## Request for Revision to Order of Conditions for Lock Pond Road Culvert Replacement (DEP FILE #286-0279)

**Subject: Locks Pond Road Bridge Replacement  
Control of Water Plan  
Shutesbury, Massachusetts  
Pare Project No.: 21139.00**

**LOCKS POND ROAD BRIDGE REPLACEMENT  
CONTROL OF WATER AT LOCKS POND ROAD  
SHUTESBURY, MASSACHUSETTS**

CONTROL OF WATER PLAN

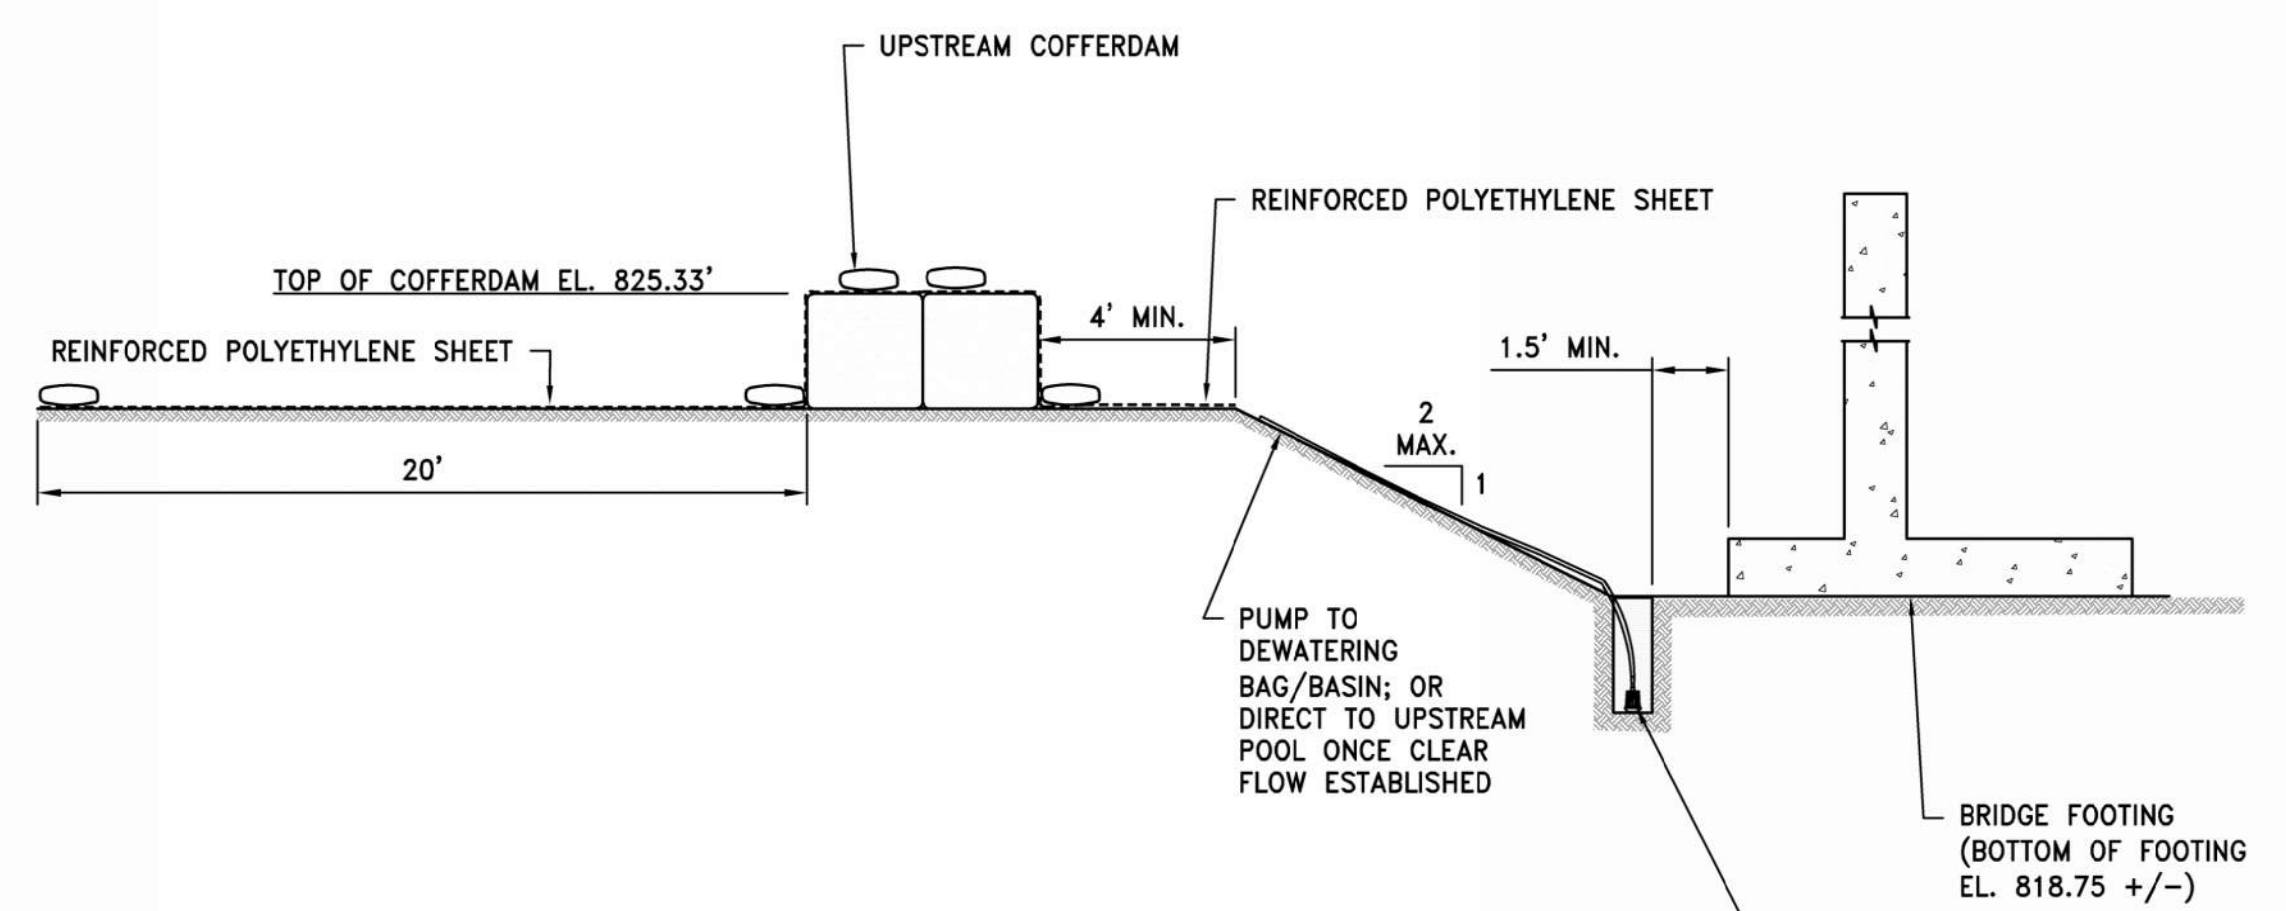
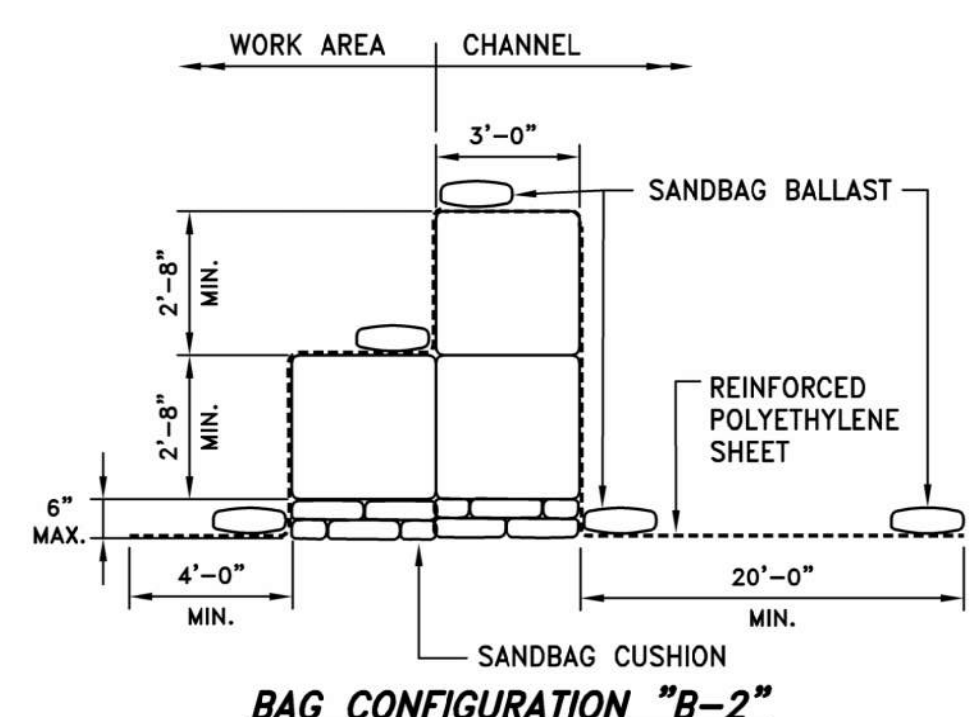
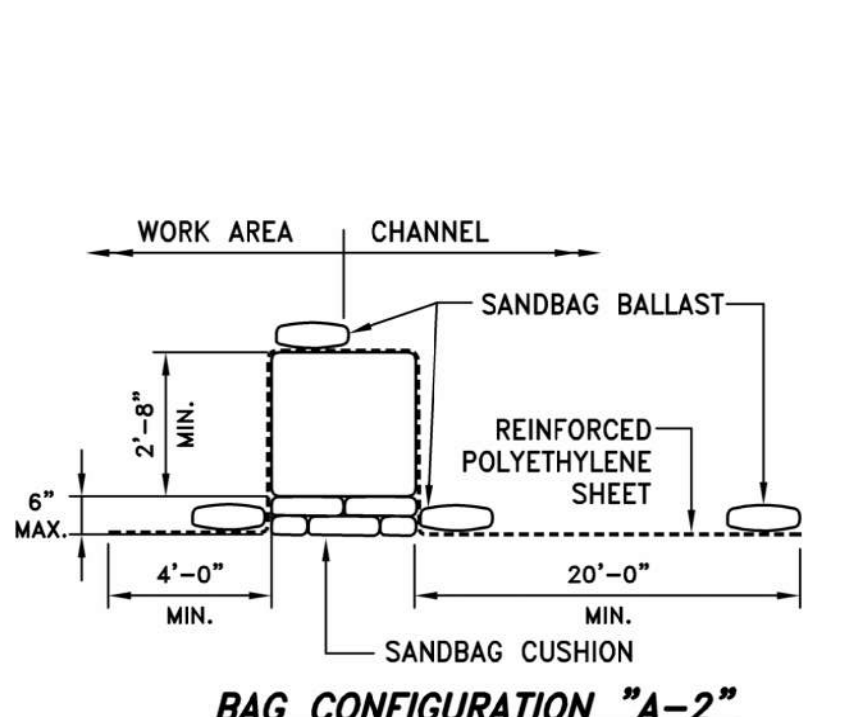
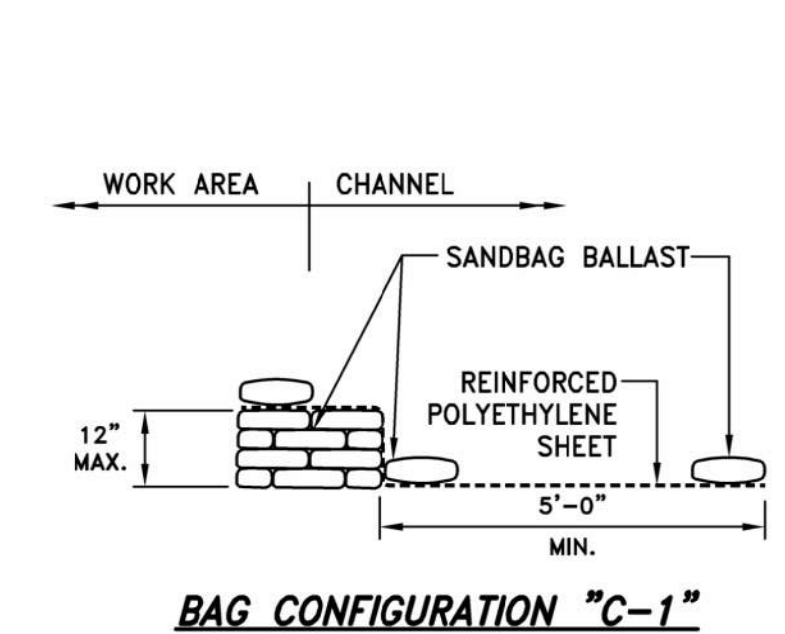
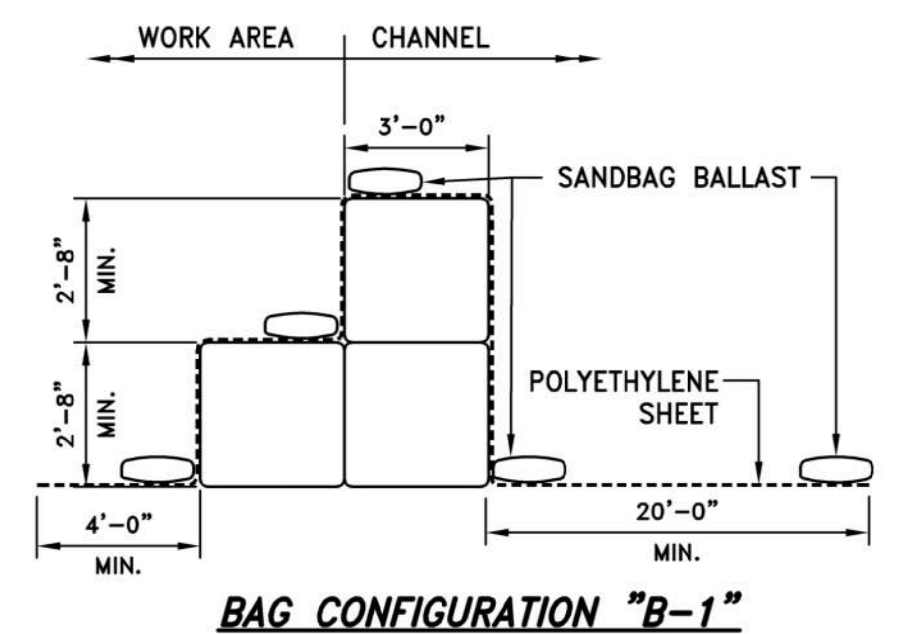
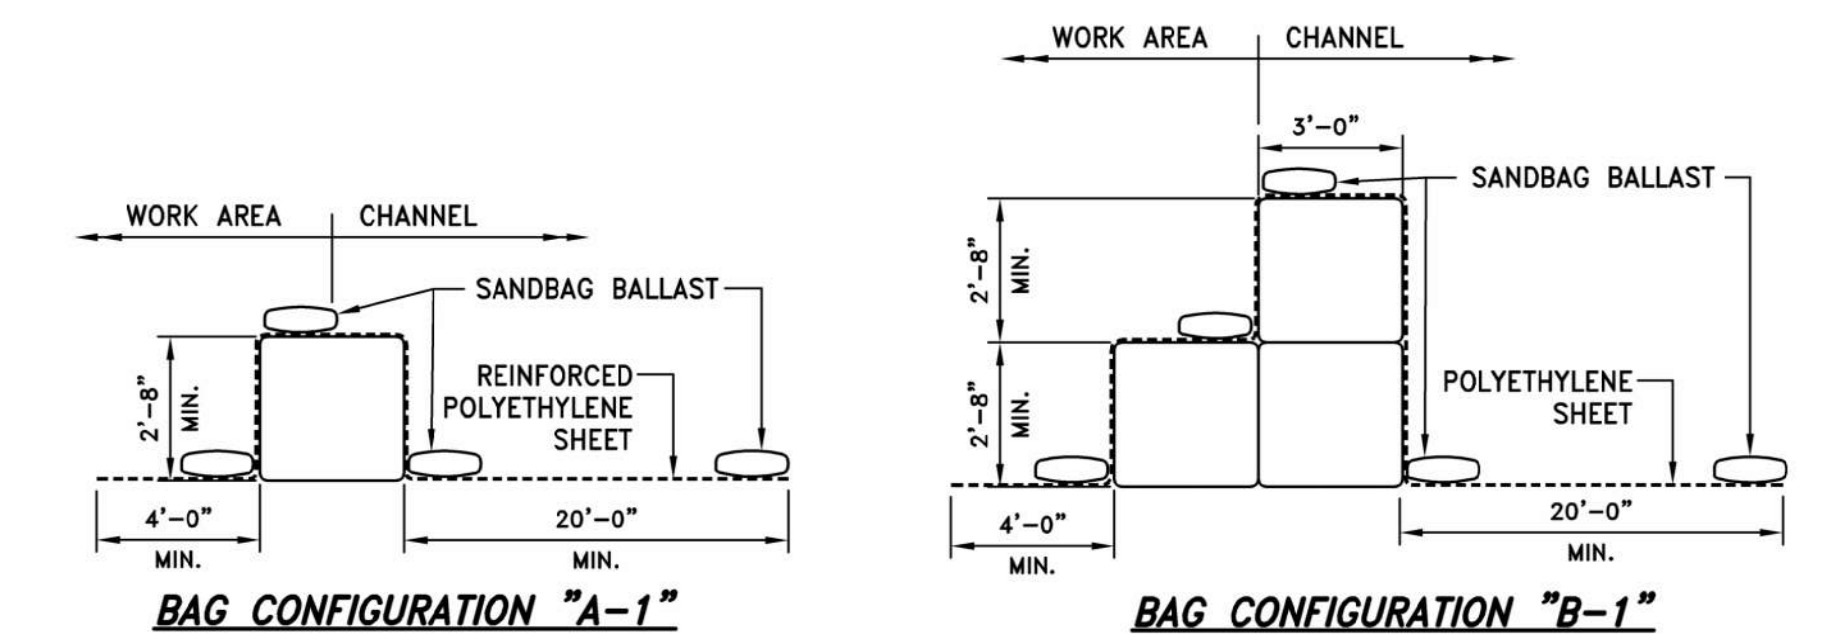
1. Per the recommendation of the Project Design Engineer, and as stated by MAS in an email dated July 27, 2023, the control of water design has been updated to accommodate flows up to 40 cfs at the Locks Pond Road Bridge Replacement site.
2. MAS has requested that the design assume a 30 cfs normal flow and be designed to accommodate up to 40 cfs without overtopping.

1	8-19-21	REVISED BYPASS PIPE ALIGNMENT & D/S DAM
2	8-16-23	REVISED BYPASS PIPE SIZE AND ALIGNMENT
